PERCOLATION CERTIFICATION PLAT

OTHER COMMENTS: The attached notes must be added to final record plat. Each lot must have a lot number on plat

OLD HACIENDA

TAX MAP 16 PARCEL 40
3rd ELECTION DISTRICT HOWARD COUNTY, MD.
SCALE: 1" = 200' AUGUST, 1981

Top Map 14

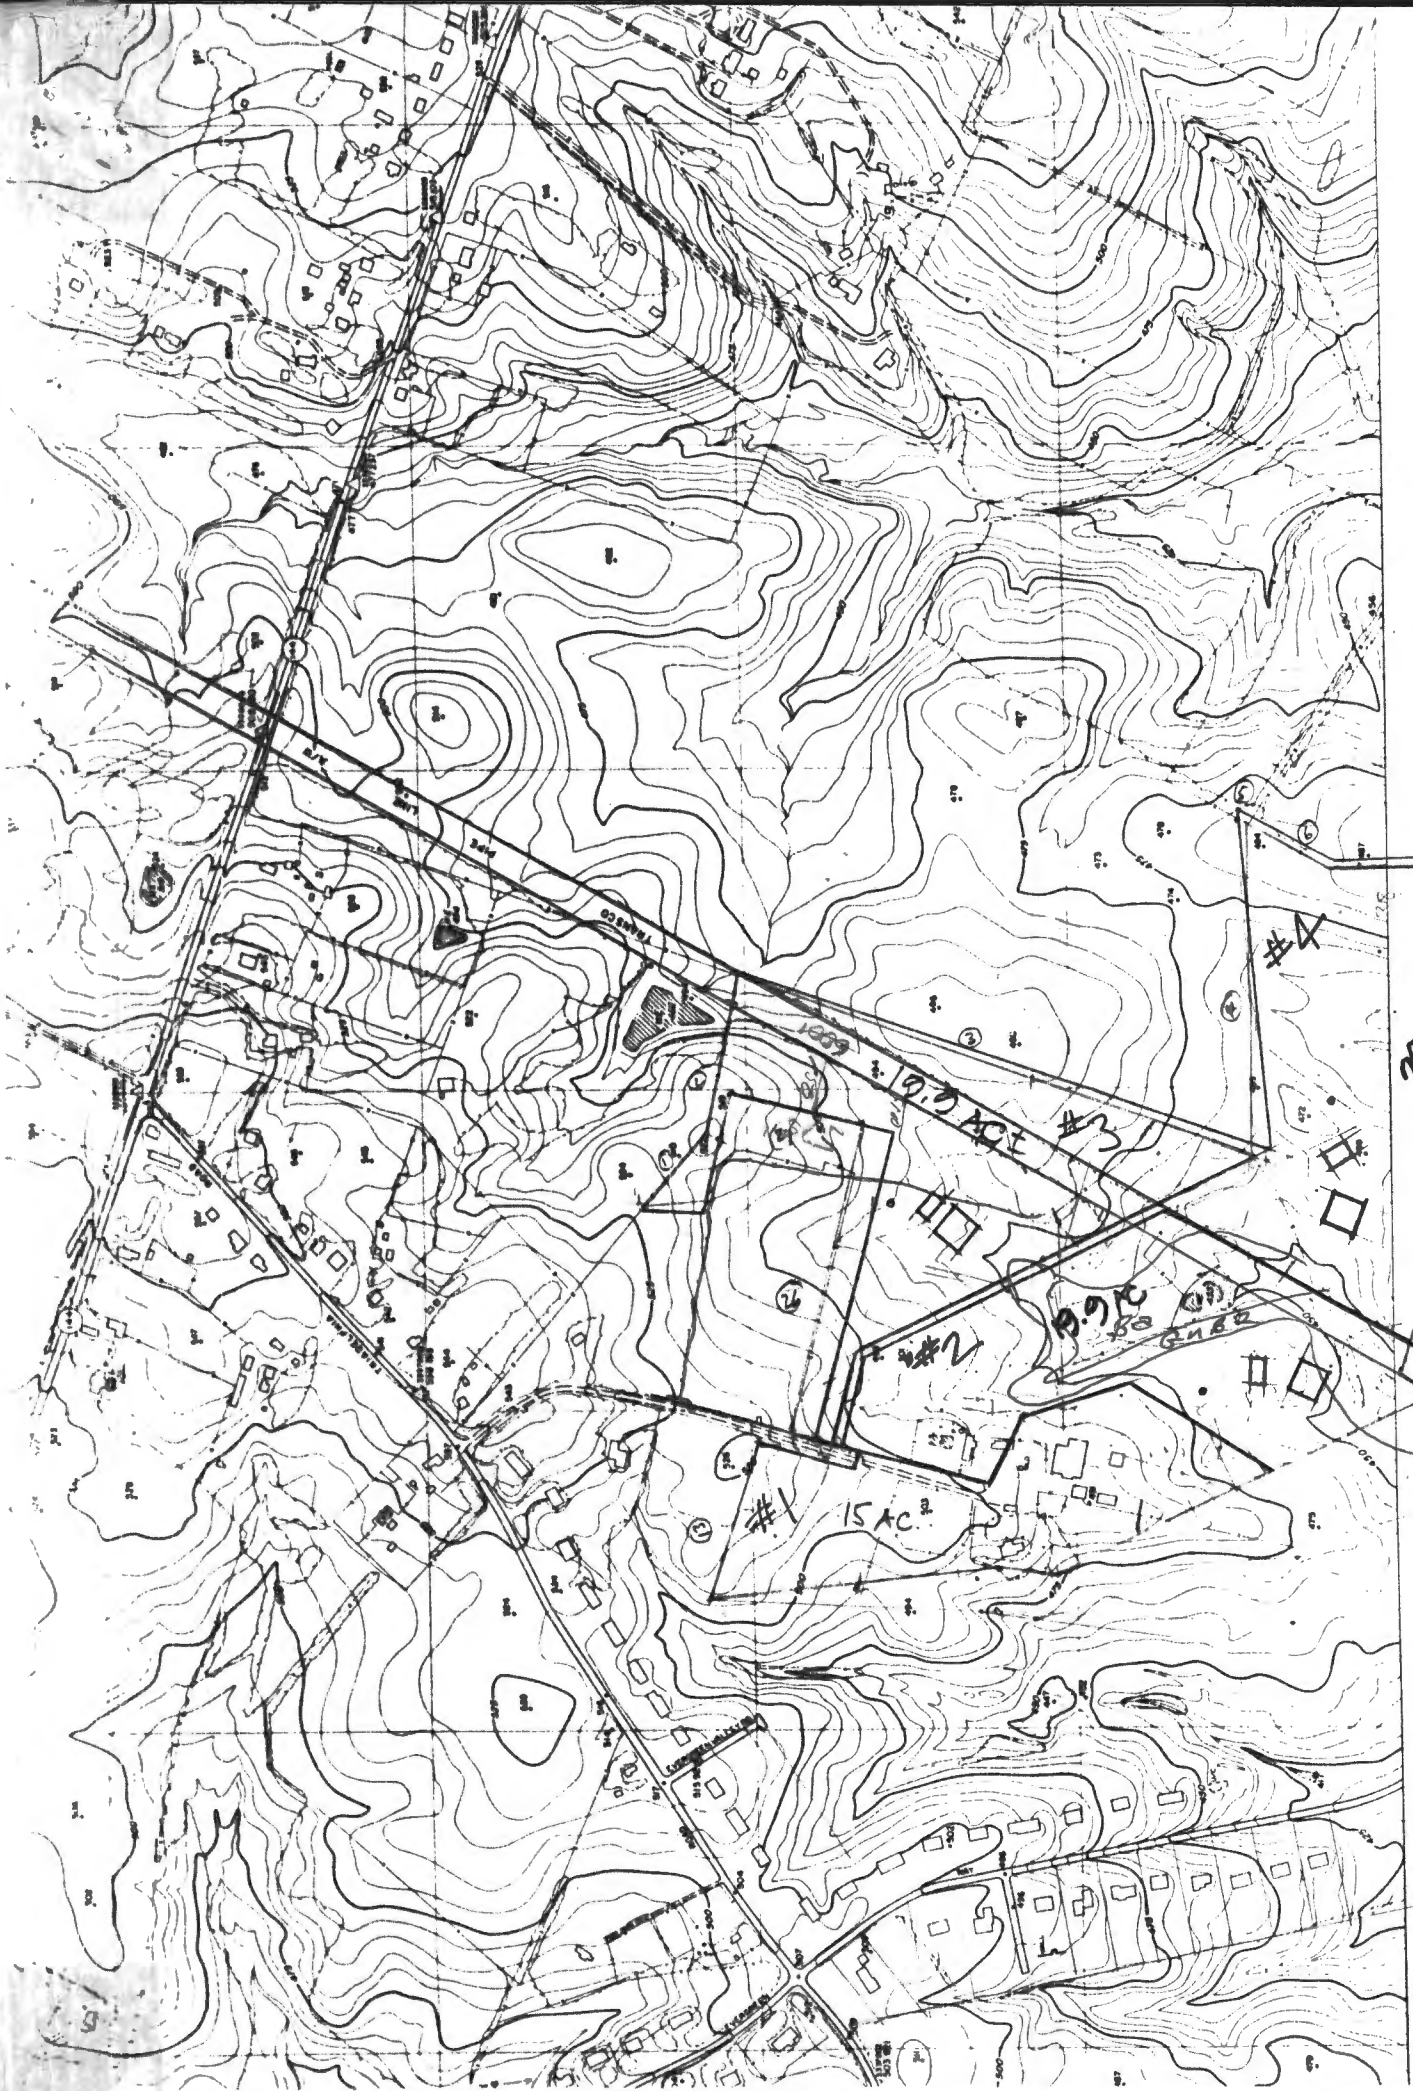
1. THE LOTS SHOULD HEREBY COMPLY WITH THE MINIMUM OWNSHIP WIDTH AND LOT AREA AS REQUIRED BY THE MARYLAND STATE DEPARTMENT OF HEALTH AND MENTAL HYGIENE.

2. THIS AREA DESIGNATES A PRIVATE SEWAGE EASEMENT OF 10,000 sq. ft. AS REQUIRED BY THE MARYLAND STATE DEPARTMENT OF HEALTH AND MENTAL HYGIENE FOR INDIVIDUAL SEWAGE DISPOSAL. IMPROVEMENTS OF ANY NATURE IN THIS AREA ARE RESTRICTED UNTIL PUBLIC SERVICE IS AVAILABLE. THESE EASEMENTS SHALL BECOME NULL & VOID UPON CONNECTION TO A PUBLIC SEWAGE SYSTEM. THE COUNTY HEALTH OFFICER SHALL HAVE THE AUTHORITY TO SUEUT VANDIUCET FOR DEL COACHM BUTT IN TO THE PRIVATE SE WAGE ESMT. RECOGNATION OF A 1000 FTD SEWAGE SWG SHALL NOT BE NECESSARY.
3. EXISTING STRUCTURE ON LOT 1

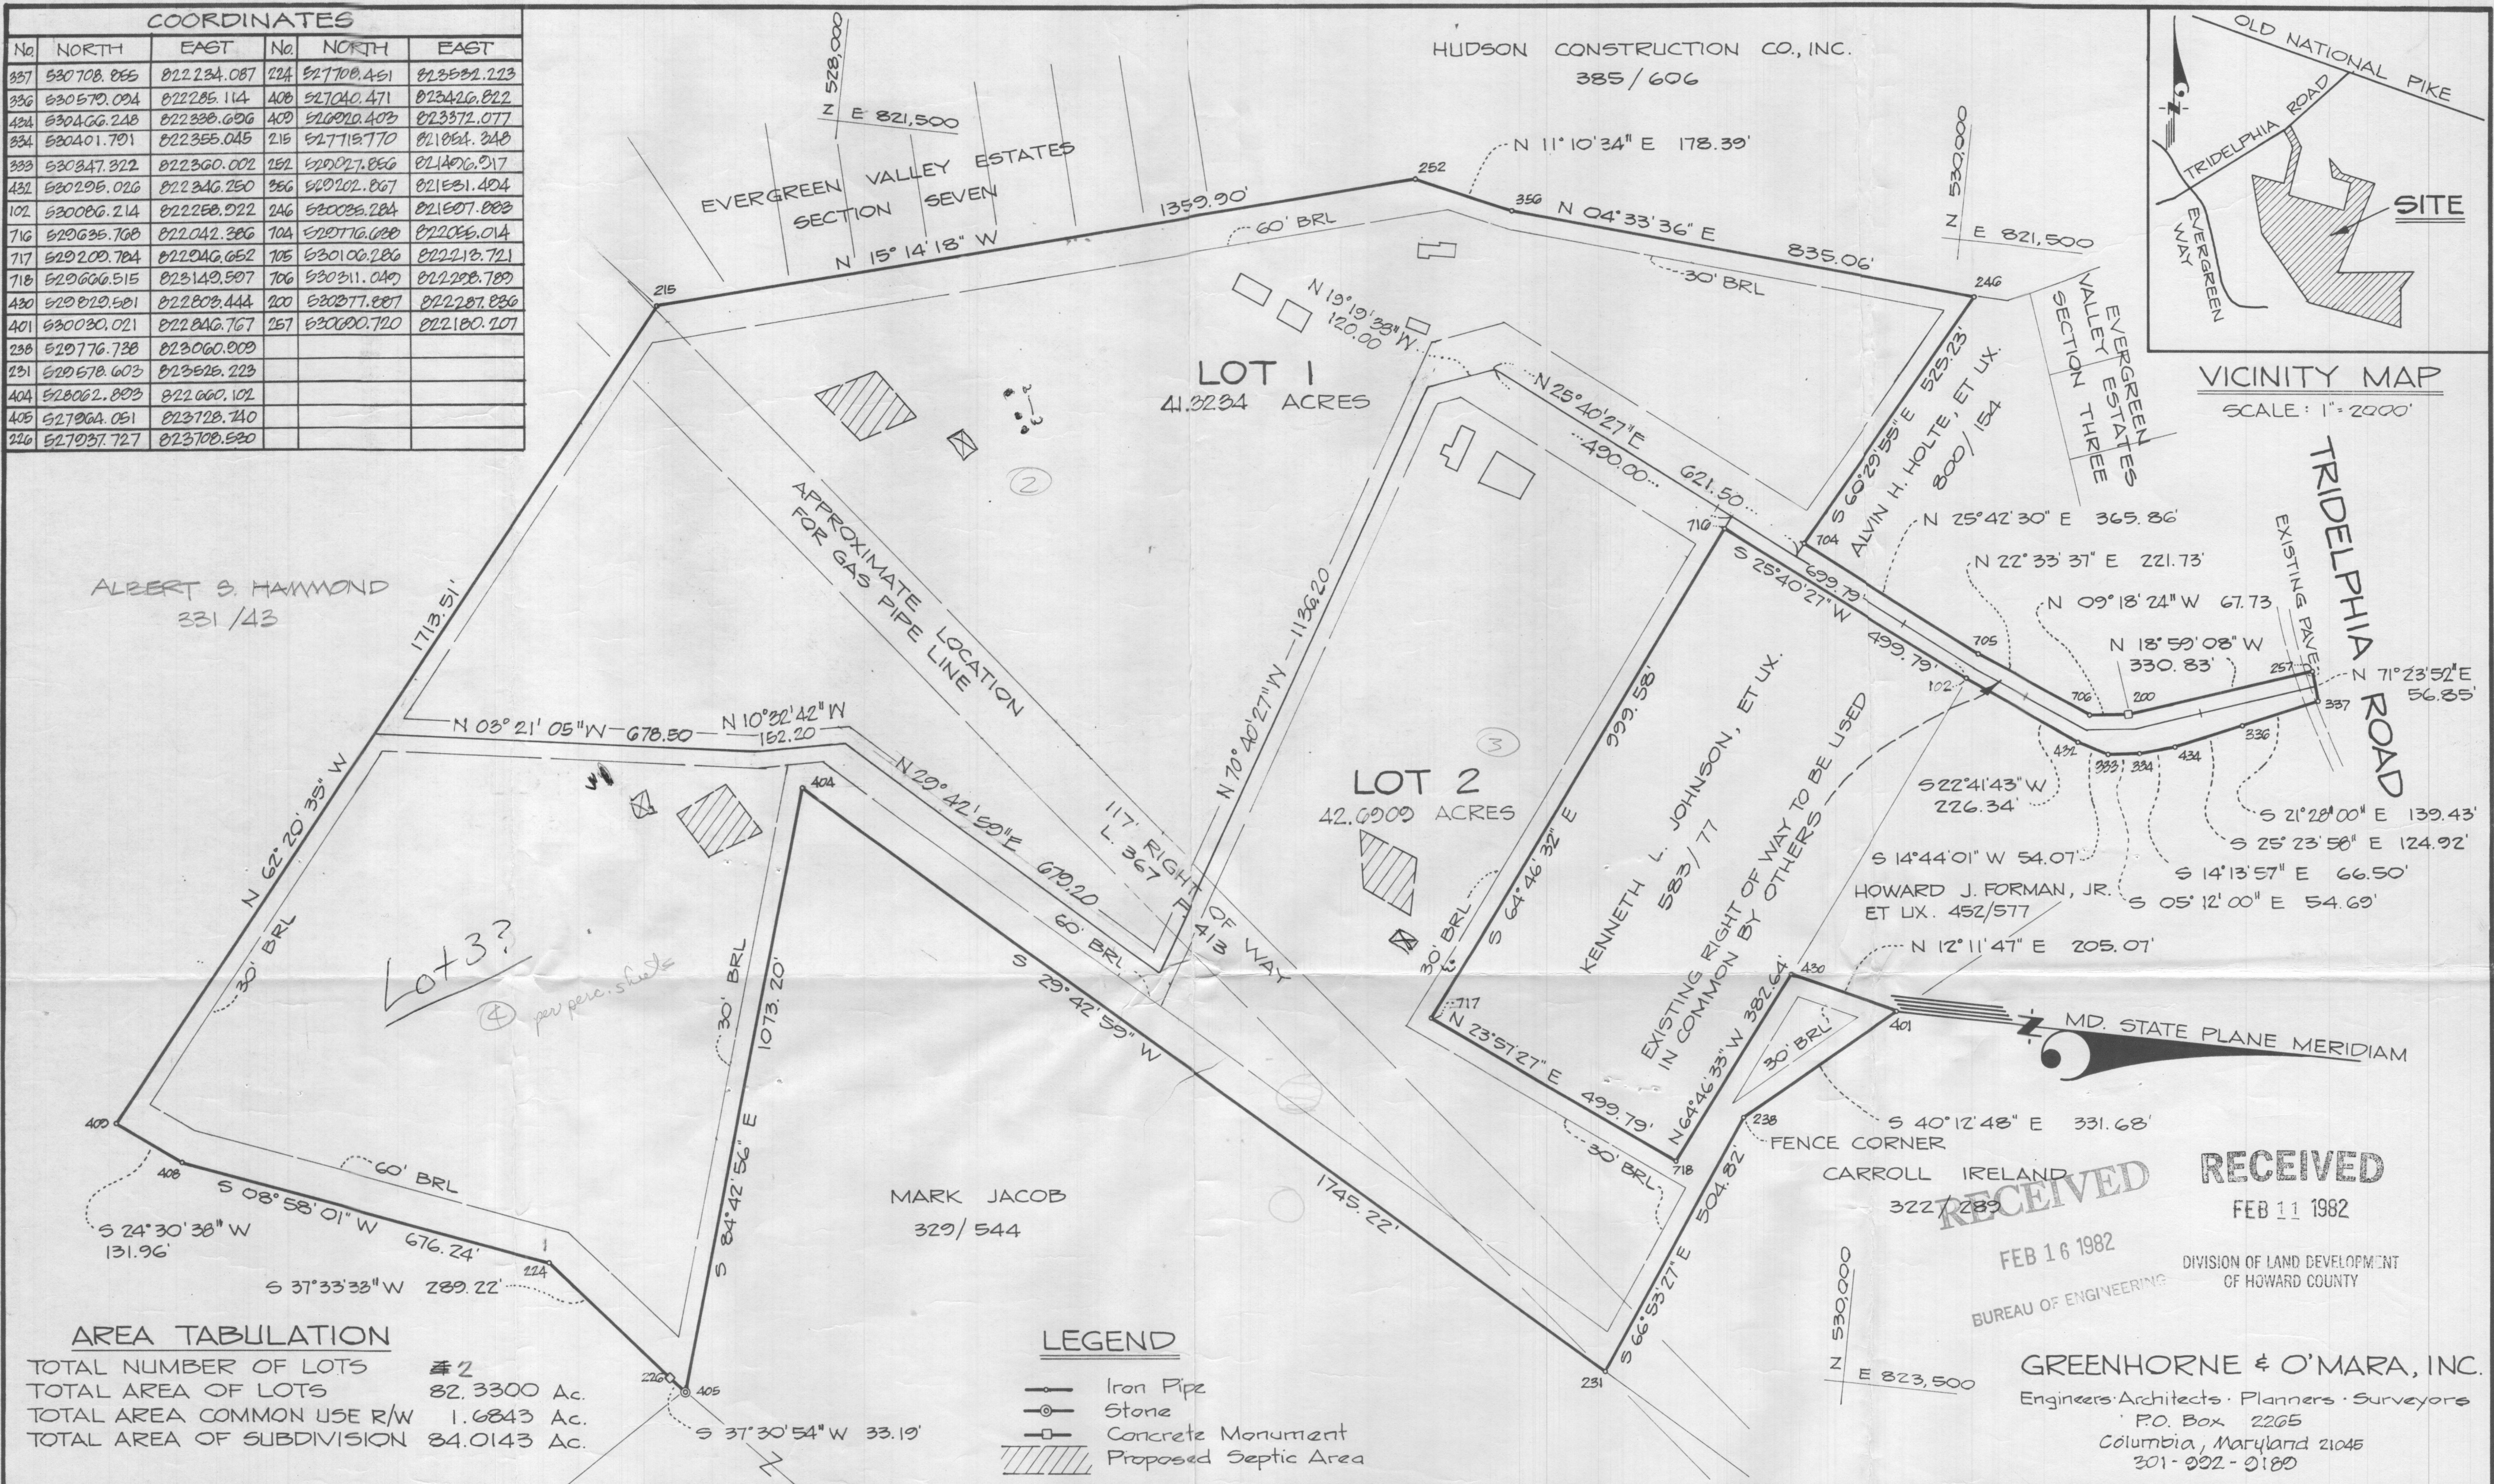
Lot 3?
⊕ per perc. sheets
